Suspension Crossmembers with AL Suspension

M-711-001

(Sep 2007)

All CXN,CXP,CXU,CHN and CHU Macks built with AL suspension.

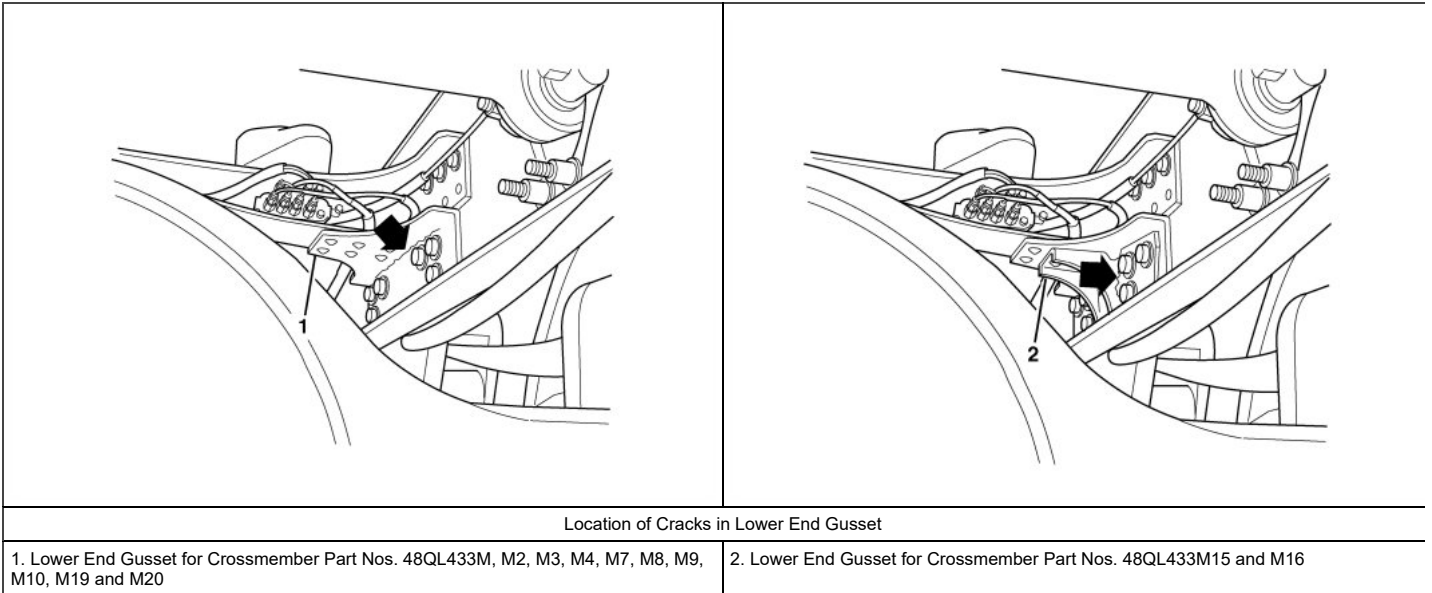
On certain CXN, CXP, CXU, CHN and CHU model chassis equipped with the MACK AL suspension utilizing rear suspension crossmember part Nos. 48QL433M, M3, M4, M7, M8, M9, M10, M19 and M20, cracks may develop in the horizontal radius of the lower end gusset. On chassis utilizing rear suspension crossmember part Nos. 48QL433M15 and 48QL433M16, cracks may develop in the lower end gusset along the mounting holes.

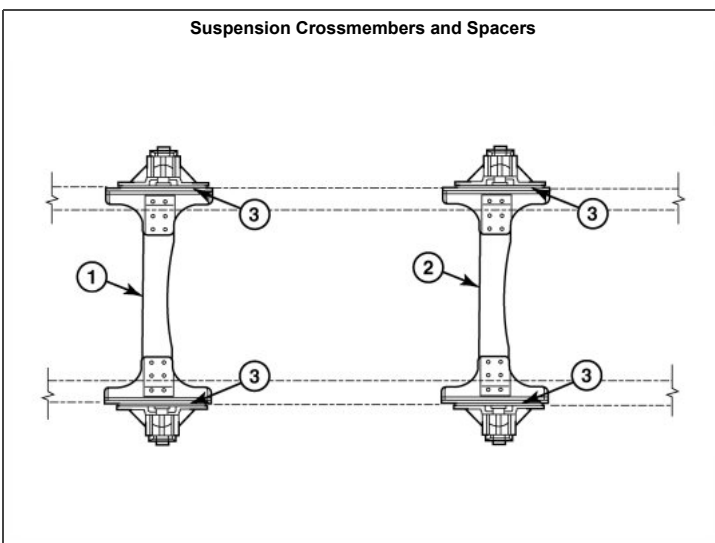
To address this issue, revised crossmembers and spacers are available through the MACK Parts System. On tandem rear axle chassis, both crossmembers must be replaced if cracks are seen in either one of the two rear suspension crossmembers.

Note: Some CXU, CXP, CXN, CHU and CHN chassis were originally assembled with crossmember part numbers 48QL433M3, 48QL433M9, 48QL433M4, 48QL433M10, 48QL433M15 and 48QL433M16, which included 5 mm spacers (part number 71RU3374M). Should replacement of one of the above mentioned crossmembers be required, the existing 5 mm spacers must be discarded and replaced with 10 mm spacers (part number 71RU3405M).

Chassis equipped with crossmember part Nos. 48QL433M3, 48QL433M9, 48QL433M4, 48QL433M10, 48QL433M15 and 48QL433M16 included 5 mm spacers (part number 71RU3374M). Should one of these crossmembers require replacement, the 5 mm spacers must be replaced with the 10 mm spacers (part number 71RU3405M).

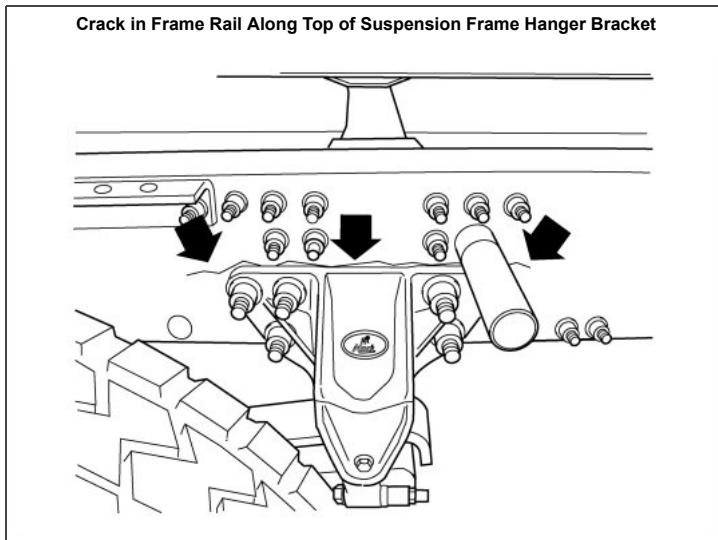
If a cracked crossmember has gone undetected for an extended period of time, the possibility exists for cracks to develop in the frame rail along the top of the AL suspension frame hanger bracket.

If a cracked frame rail is encountered, the affected rail must be replaced.
